# Access Compliance Report

## Public Rights-of-Way

### (Curb Ramps)

Intersection ID: N/A	Main Street: WESTINGHOUSE_BV	Cross Street: CORDAGE_ST	Location: NE
ADA ID: 2060EF6365B9	Ramp Type: PerpDiag	Initial Pass/Fail: Fail	Overall Compliance: No
Codes/Mitigation Info/Possible Solution		Field Measurements/Component Compliance

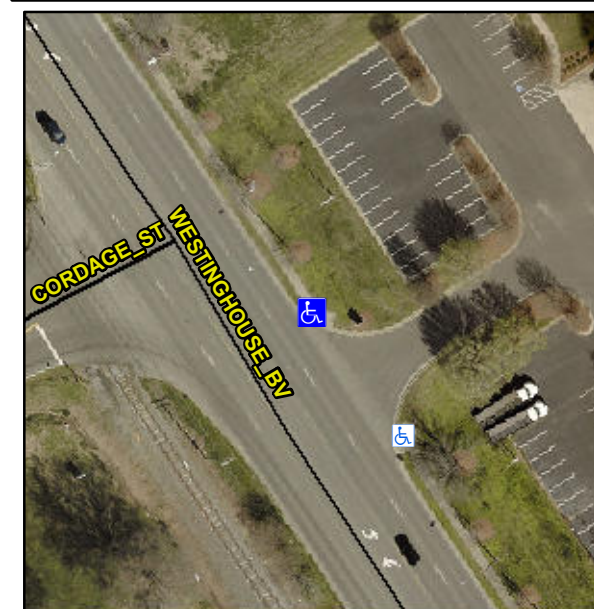
**R304.5.1, R304.5.3**

Compliance	Description	Data	Compliance	Description	Data
N/A	Ramp Length (in)	86.0	Yes	Ramp Slope (%)	6.4
No	Ramp Width (in)	43.0	No	Ramp XSlope (%)	3.4
N/A	Flare Type LT	N/A	N/A	Flare Type RT	N/A
N/A	Flare Slope LT (%)	N/A	N/A	Flare Slope RT (%)	N/A
N/A	Flare Traversable LT?	N/A	N/A	Flare Traversable RT?	N/A
N/A	Landing Length (in)	N/A	N/A	DWS Provided?	N/A
N/A	Landing Width (in)	N/A	N/A	DWS Contrast?	N/A
N/A	Landing Slope (%)	N/A	N/A	DWS Length (in)	N/A
N/A	Landing X Slope (%)	N/A	N/A	DWS Full Width?	N/A
N/A	Landing Curb? (Y/N)	N/A	N/A	DWS Offset (in)	N/A
N/A	Shared Landing?	N/A			
N/A	Gutter Ponding?	N/A	N/A	Gutter Slope (%)	N/A
N/A	Gutter Lip Ht (in)	N/A	N/A	Gutter X Slope (%)	N/A
N/A	Painted X Walk1?	No	N/A	Painted X Walk2?	No
	X Walk 1 Direction	To W		X Walk 2 Direction	To S
N/A	X Walk 1 Width (in)	N/A	N/A	X Walk 2 Width (in)	N/A
	X Walk 1 Slope (%)	3.0		X Walk 2 Slope (%)	1.3
	X Walk 1 X Slope (%)	0.3		X Walk 2 X Slope (%)	3.9

**Remove & Replace Curb Ramp With Two New Directional Ramps or Equivalent.**
